# information bulletin

November 2019

## Bourke Road, Clarinda – Proposed speed humps

## Proposed traffic measure adjacent 150 Bourke Road

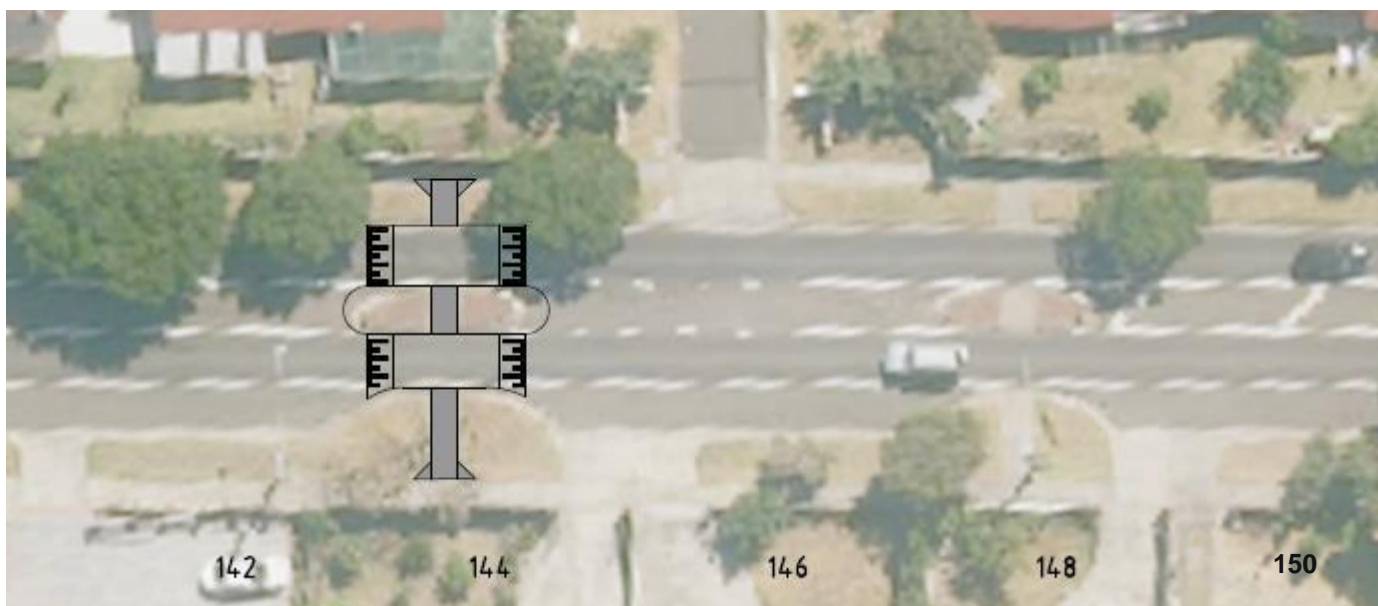
In August, Council wrote to residents regarding the feedback received on proposed traffic calming measures on Bourke Road. The feedback showed strong support from residents for the measures shown in the attached plan. The plan shows four speed humps, including a hump adjacent to 144 Bourke Road and Clarinda Retirement Village. During the detailed design, Council identified drainage issues associated with providing a hump adjacent to number 144.

Consequently, Council is proposing to relocate the hump (with new kerb-buildouts and a pedestrian refuge island) approximately 40m to the east - opposite 150 Bourke Road (see attached plan). The existing kerb outstand and centre island at number 148 Bourke Road will also be removed. Relocating the proposed hump to this new location will remove the need for extensive drainage works.
